North Carolina Department of Environment and Natural Resources  
Division of Water Quality

July 22, 2010

Subject: **NOTICE OF VIOLATION**  
**NOTICE OF INTENT TO ENFORCE**  
NOV-2010-SS-0036  
DWQ Project # 98-0592 and DWQ Project # 06-1404  
Kitrell Quarry  
36.17509°N, -78.44049°W  
Removal of Best Usage  
Other Waste (in-stream sediment)  
Wetland Standards Violation  
401 Water Quality Certification Condition Violations  
Tar-Pamlico River Riparian Buffer Violations  
**Vance County**

Figure 1: Current conditions on site

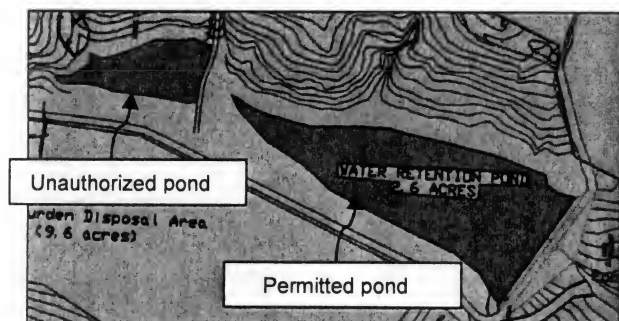
- Approximately 320 linear feet of stream channel had been impounded (see Figure 1) upstream of the authorized sediment control impoundment/stormwater detention pond (see Figure 2);

- Sediment deposition measuring 2-12 inches was observed in approximately 600 linear feet of stream channel upstream of this unauthorized impoundment. This portion of stream channel was also showing signs of bank failure and appeared to have been excavated in the past;

- A feature that is depicted on the *Soil Survey of Vance County* had been excavated approximately 320 linear feet upstream of the unauthorized impoundment;

2. Explain in your response how and when you anticipate being in full compliance with the 401 WQCs.
3. Stream Restoration Plan (excavation and impoundment impacts) – Please explain how you plan to restore the pattern, profile and dimension of the impacted stream channels. The streambed must be restored to the original profile, the stream banks must be stabilized, and any fill material must be removed from the riparian zone. Replanting of the riparian zone will be required.

Figure 2: Lower Pond Authorized in DWQ Project # 98-0592

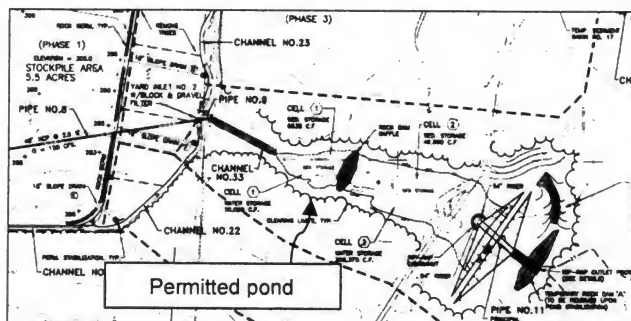
The 401 WQC DWQ Project # 98-0592 approval letter specifies that the approval is only valid for the purpose and design that you described in your application. If you change your project, you must notify DWQ and send us a new application.
